CITY PLANNING COMMISSION

B. Special Permit to expand an existing mosque by constructing two buildings totalling 4,370 sq. ft. on one \pm acres in the Light Industrial (M-1) zone.

LOCATION: 7320 14th Avenue

APPLC. NO. P88-228 MEETING DATE June 23, 1988 ITEM NO. 22

EXHIBIT B

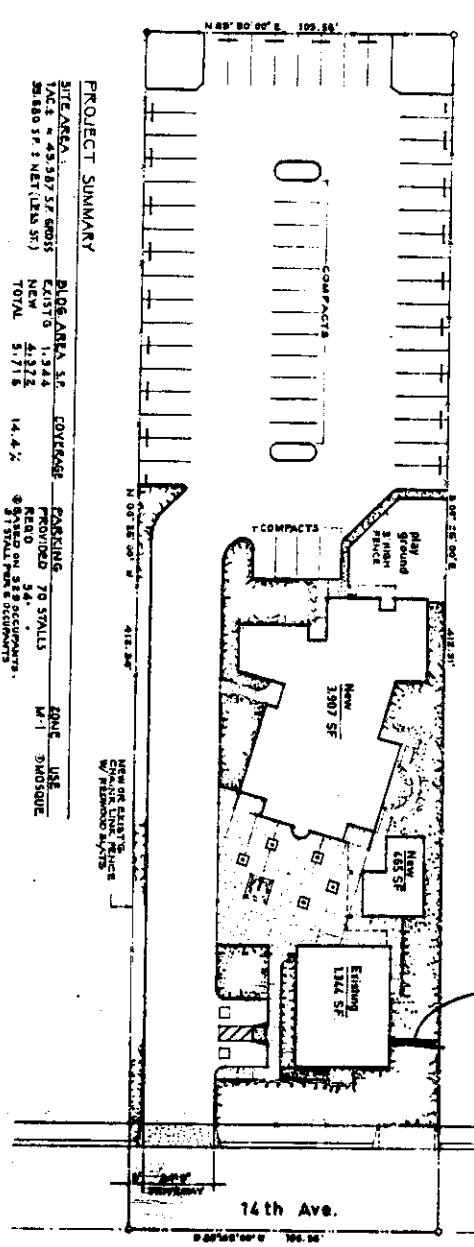
The existing parking layout shows a total of 60 parking spaces at a rate of one space per six seats (325 seats proposed). Fifty-five parking spaces are required. A revised landscape plan shall reflect the City's Tree Shading requirements and shall incorporate the following changes:

- o Replace bumper stops with a two foot landscape planter along the south, east and west property lines.
- o The four compact spaces on the north side of the parking lot should overhang two feet. Sidewalks and landscaping should be designed to accommodate this revision.
- o The back up area for the two handicapped parking spaces needs to be 28'.
- o All parking areas will be required to be surfaced per City standards.

1. Eliminate existing unused driveway on 14th Avenue.
2. Create one-way circulation in parking lot.
3. Provide 26 foot maneuvering depth.
4. Repair or replace any substandard improvements.

1. The applicant shall submit, to the Planning Director for review and approval, a revised parking and landscape plan which shall include:
 - a. replacement of bumper stops with two \pm foot landscape planter along the south, east and west property lines.

- b. two foot overhang for the four compact spaces on the north side of the parking lot (sidewalk(s) and landscaping to accommodate this revision).
 - c. a 26 foot backup area for the two handicapped spaces.

- d. a note indicating that parking and driveway areas to be surfaced to City Standards.
2. A six foot high decorative masonry wall shall be constructed along property lines adjacent to residential uses and zones. The wall shall be constructed prior to final building inspection approval.

**EXHIBIT C
ELEVATIONS**

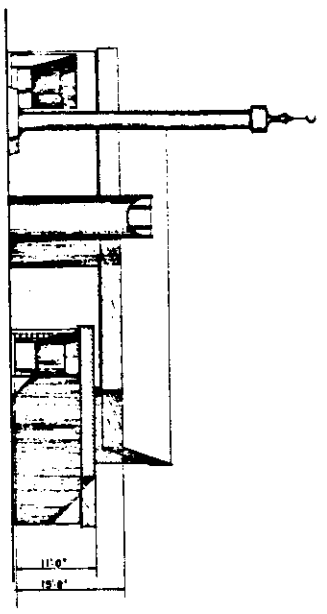
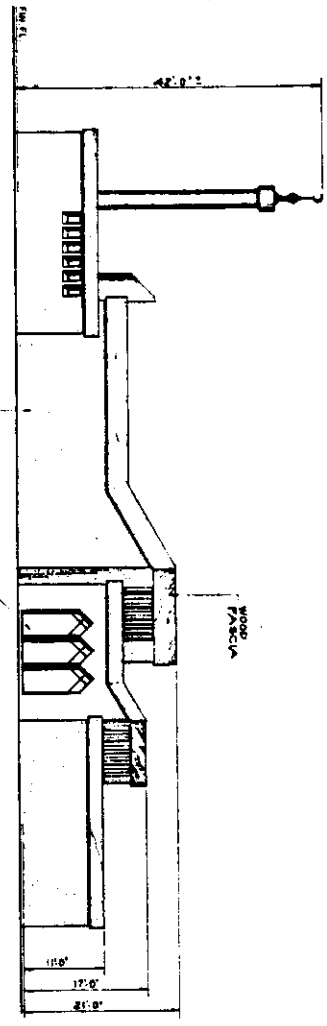
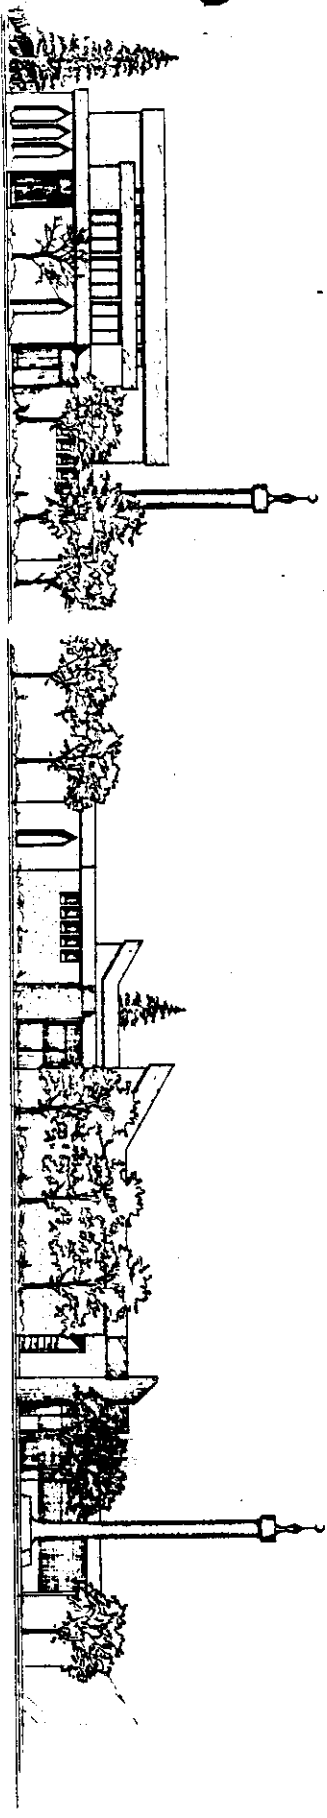
The existing residence on the property, however, is of an architectural style that differs from the proposed structures. An attempt should be made to tie these buildings together. Architectural solutions which would be best in tying these structures together would be costly. With cost in mind, staff recommends that a wing wall be added to the westerly side of the existing structure to help form a compound to help unify the structures. The wing wall should extend from the existing structure to the westerly property line. The wing wall and existing building should be painted to match the proposed structures.

5. A wing wall shall be constructed between the existing structure and west property line. The wall and existing structure shall be painted to match the proposed structures.
